ST/SG/AC.10/36/Add.3
9 March 2009

**REPORT OF THE COMMITTEE OF EXPERTS ON THE TRANSPORT OF
DANGEROUS GOODS AND ON THE GLOBALLY HARMONIZED SYSTEM OF
CLASSIFICATION AND LABELLING OF CHEMICALS ON ITS FOURTH SESSION**
(Geneva, 12 December 2008)

Annex III

Amendments to the second revised edition of the Globally Harmonized System
of Classification and labelling of Chemicals (GHS) (ST/SG/AC.10/30/Rev.2)

“3.8.5.1 Decision logic 3.8.1

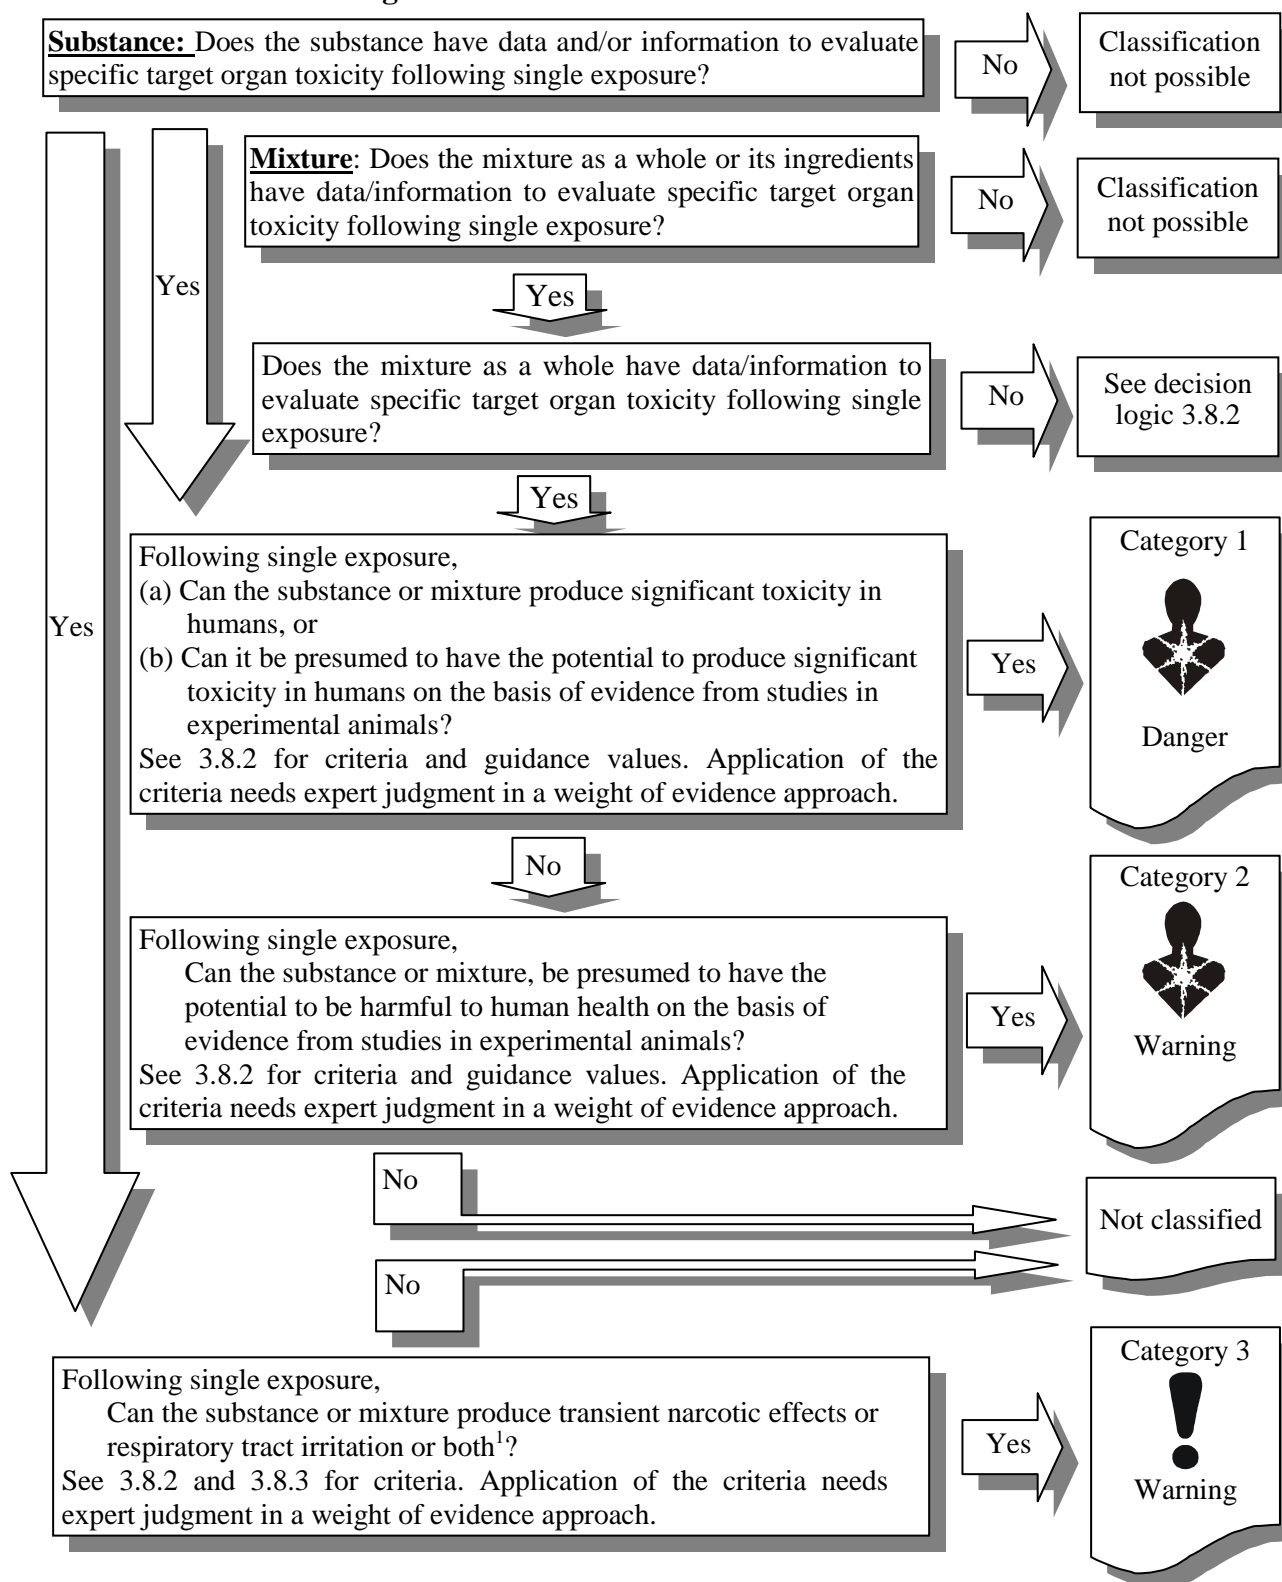
- 3.8.5 Amend decision logics 3.8.1 and 3.8.2 in chapter 3.8 to read as follows (current introductory paragraph under 3.8.5 remains unchanged):

“Figure 4.1.1: Categories for substances long-term hazardous to the aquatic environment

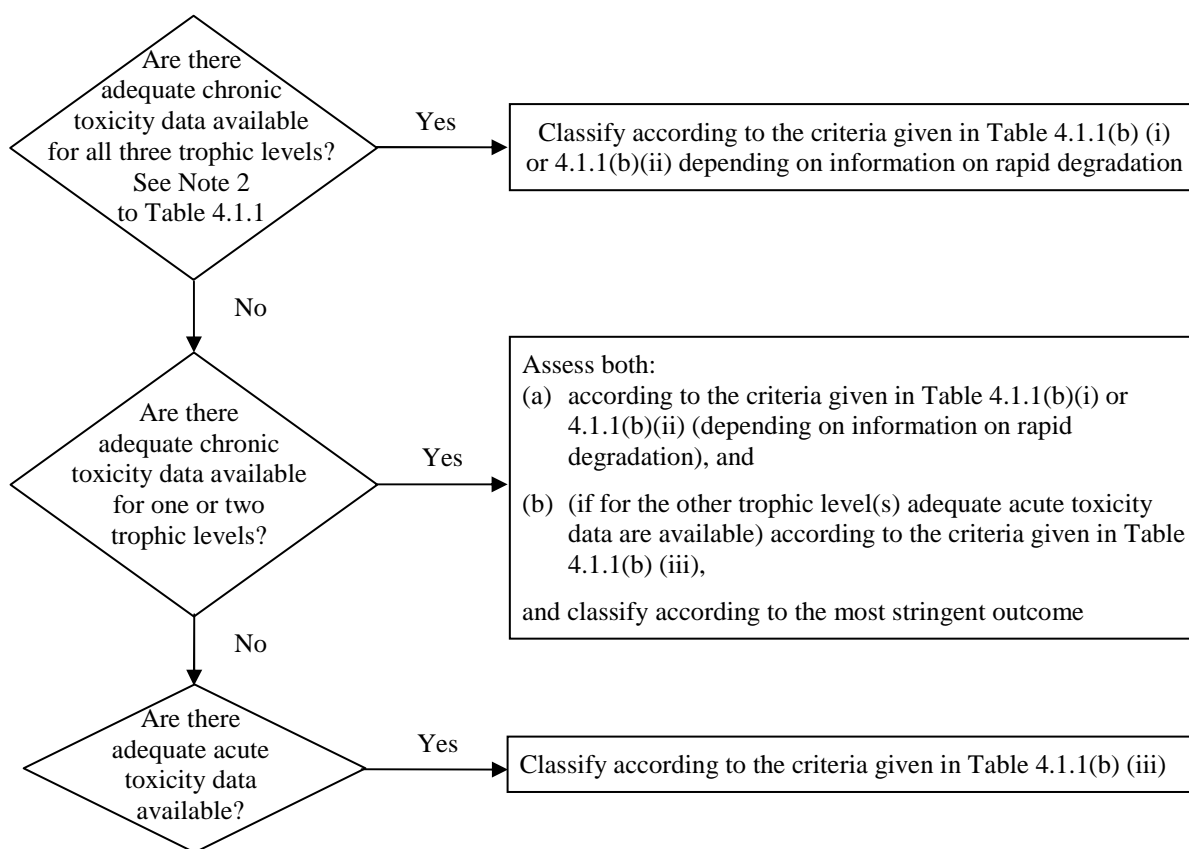
Figure 4.1.1: Insert a new figure 4.1.1 to read as follows:

4.1.5.1.1 Decision logic 4.1.1 for substances and mixtures hazardous to the aquatic environment

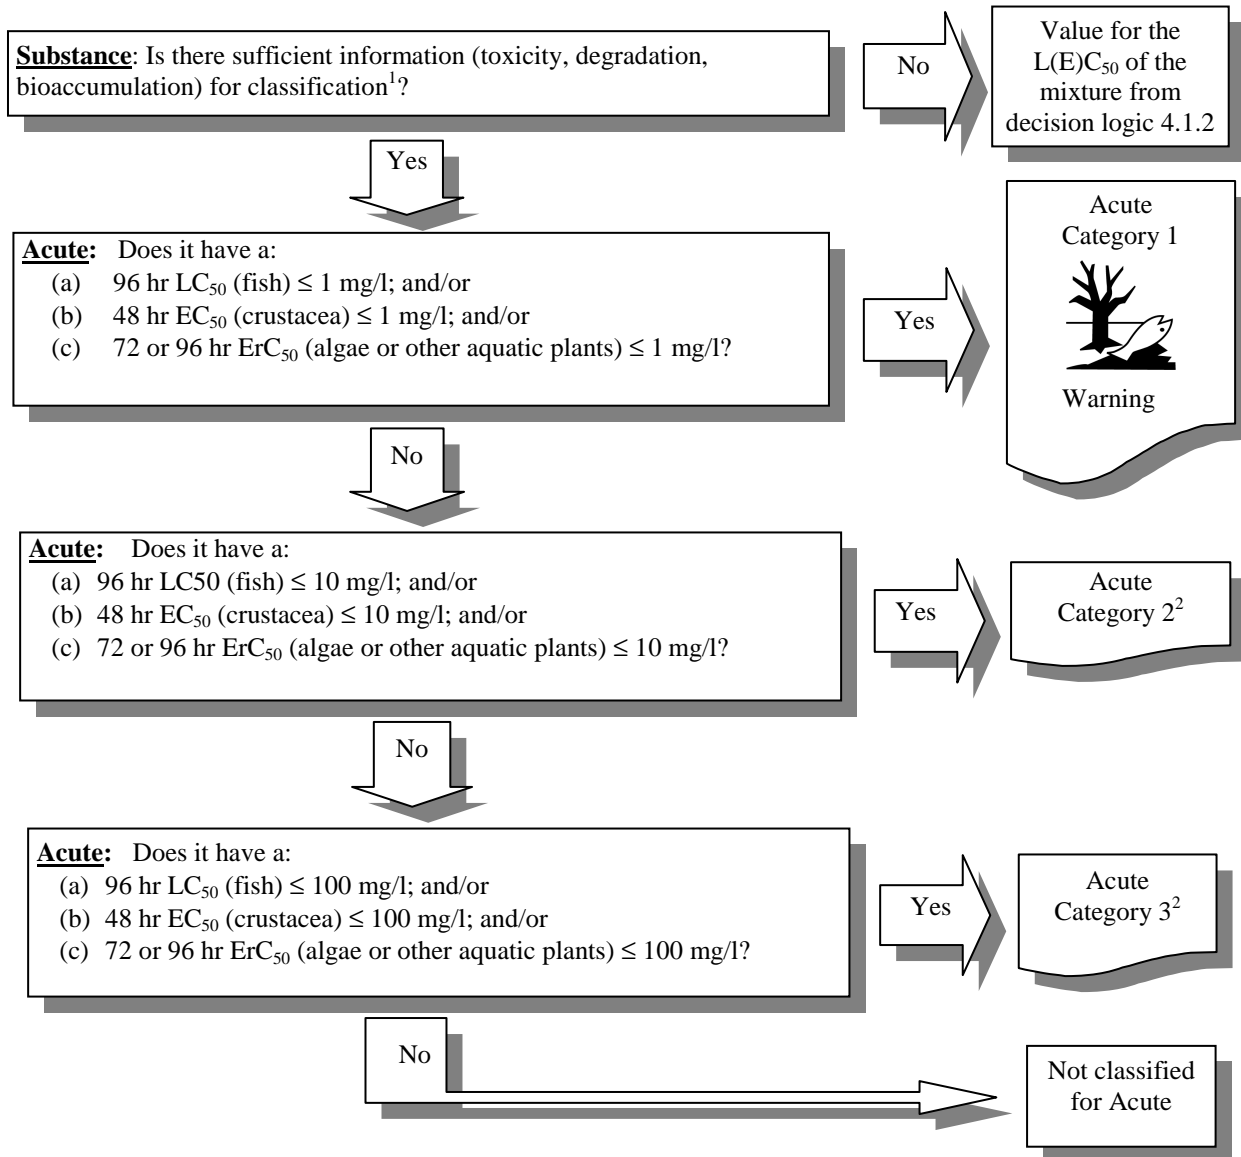
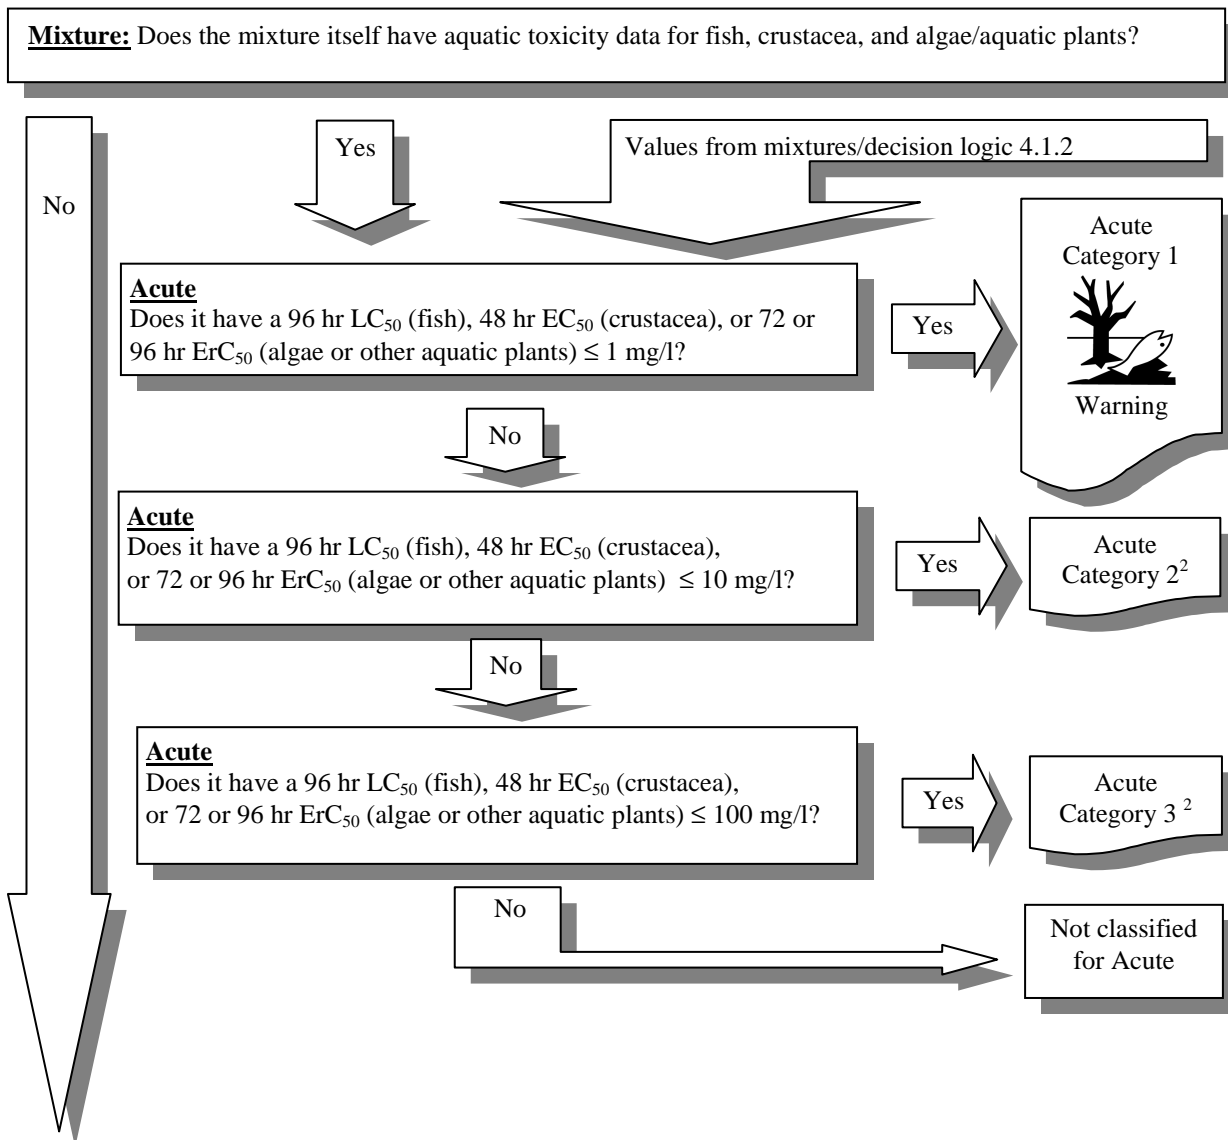
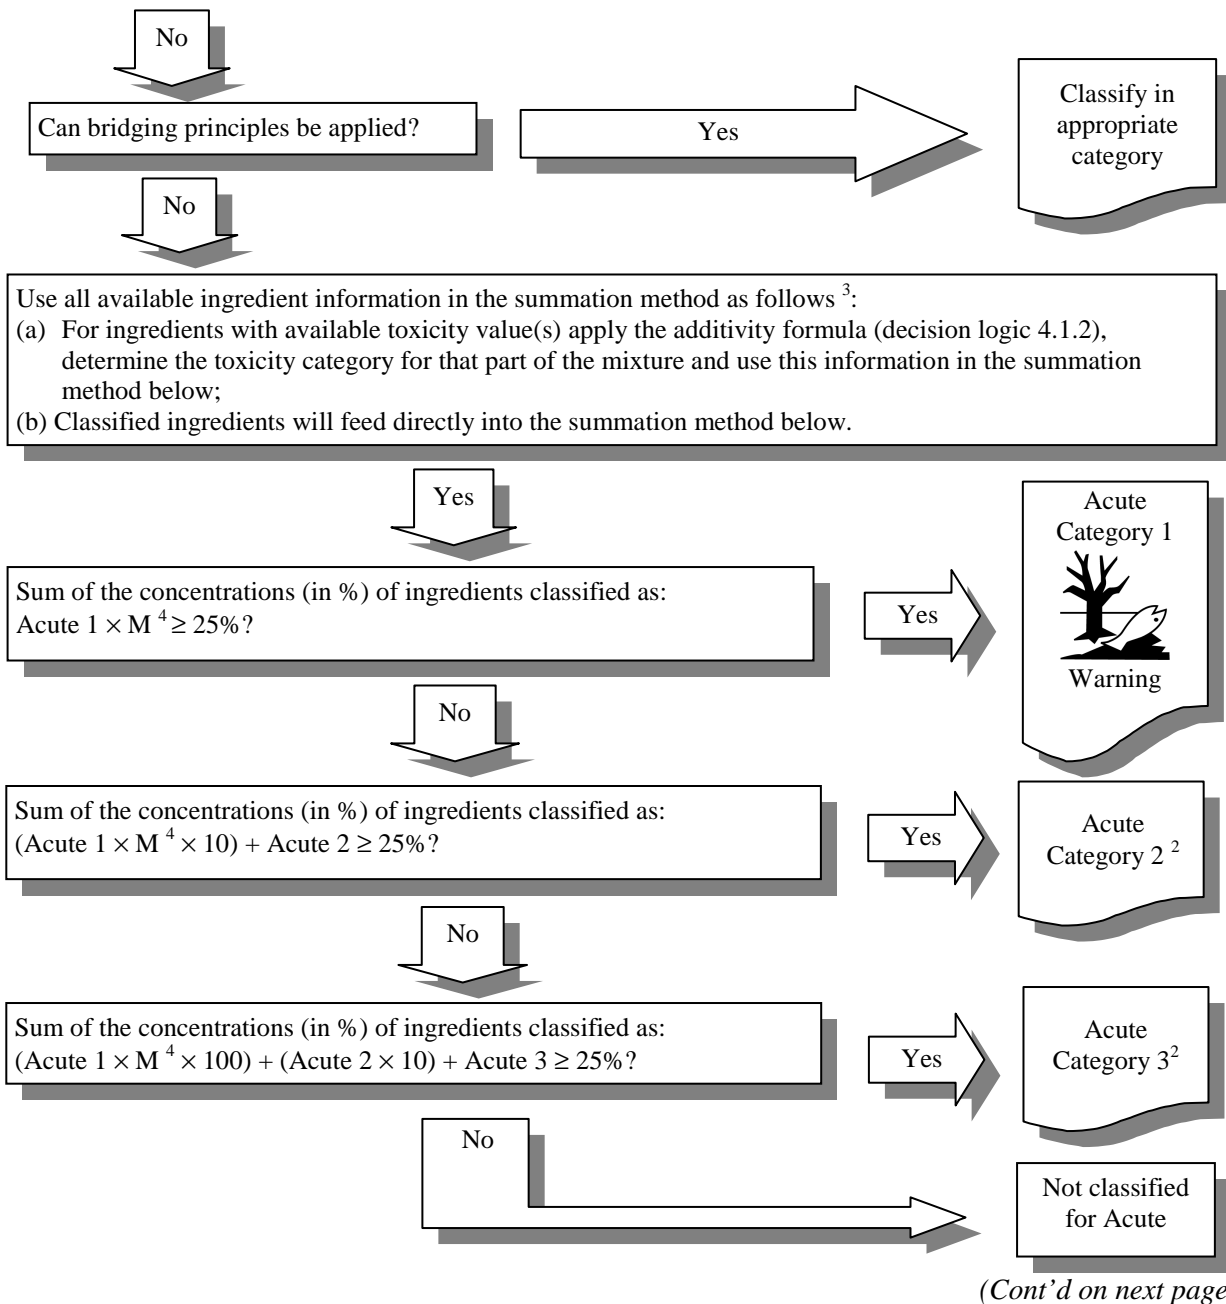
4.1.5.1 Replace current decision logics with the following:
